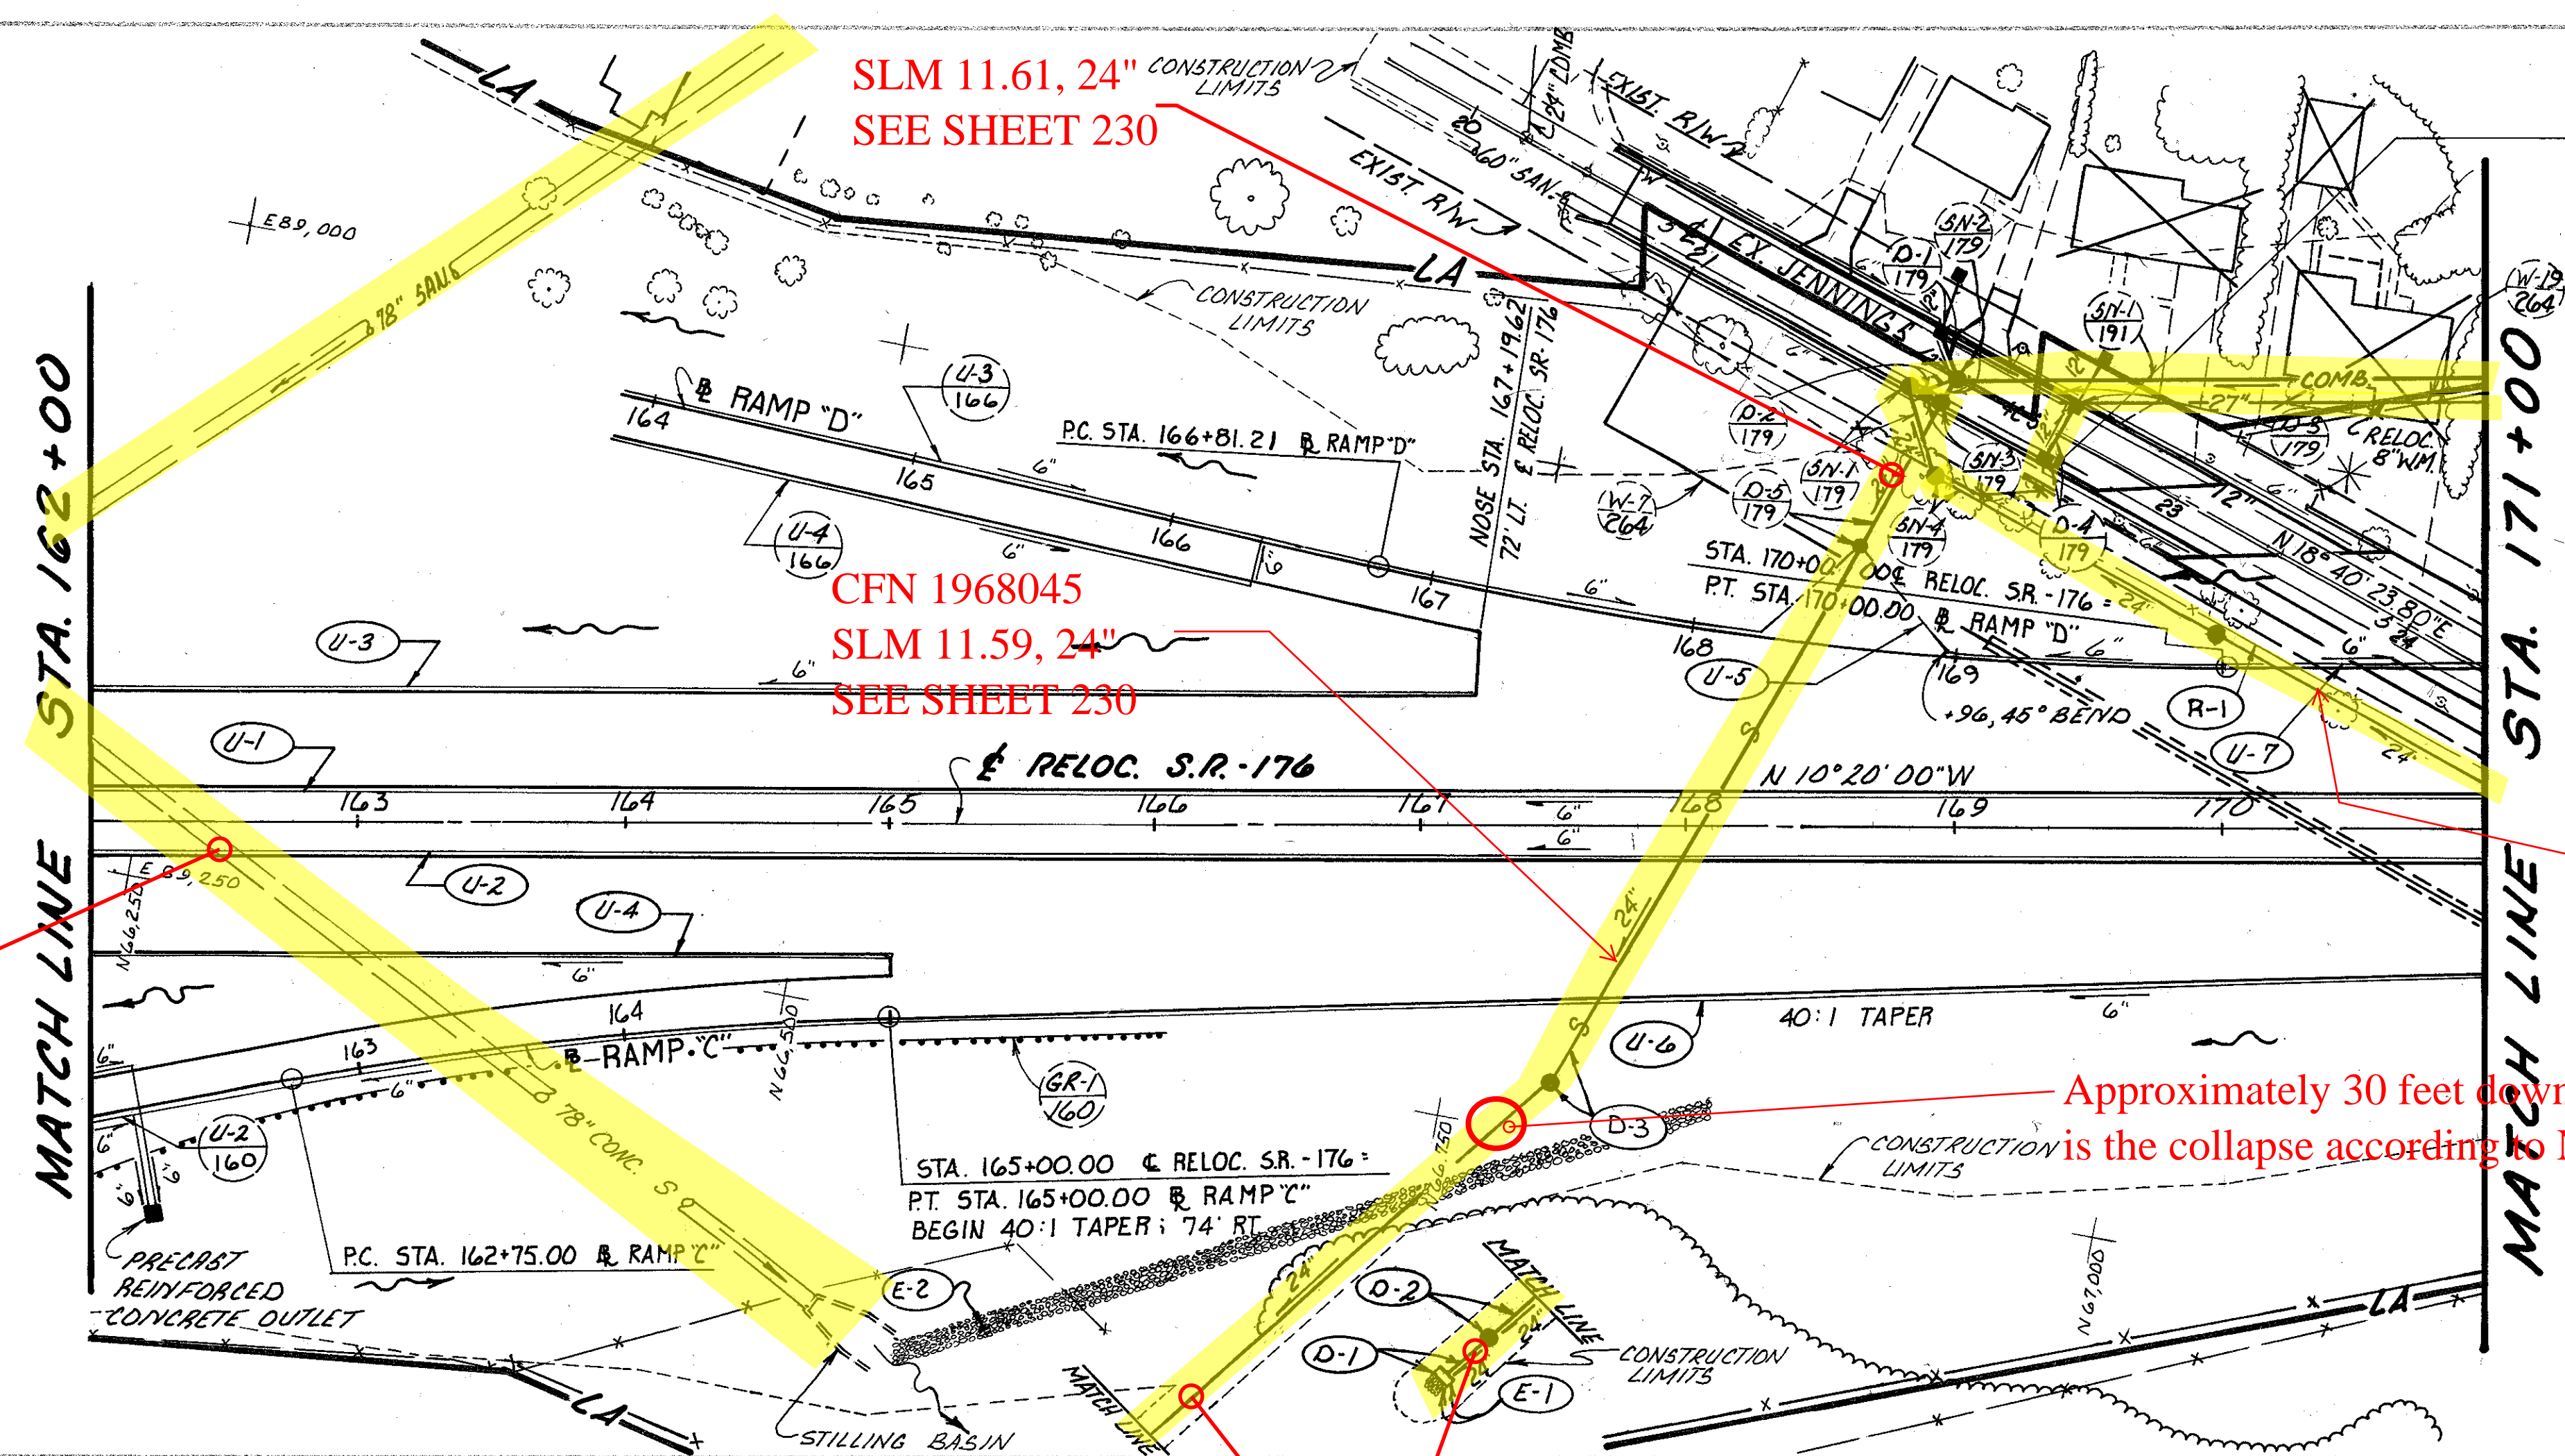
old CFN 181761146
 new CFN 1803545
 SLM 11.45, 78"

Approximately 30 feet downstream of MH is the collapse according to NEORS.D.
